**TDK Corporation**

**Process Change Notice**

**Notification for Dummy Pattern Abolish for Chip NTC Thermistors**

2. Dummy pattern abolish and target products

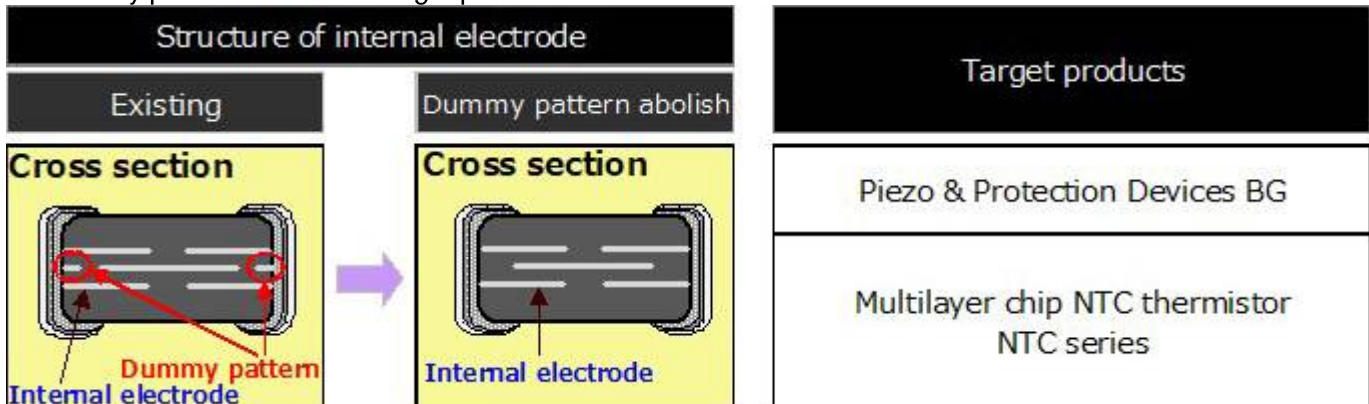
In response to the recent trend of increasing global demand for palladium, we have decided to abolish the dummy pattern that do not affect product characteristics, in order to ensure a stable supply of our chip NTC thermistors.

There is no change in product name, specifications (appearance, dimensions, electrical characteristics), reliability, process control plan, etc.

Dummy electrode abolish have already been adopted for our new products, and we have some their shipment. We would like to inform you that we would like to apply the dummy pattern abolish even in the existing products that we have already provide.
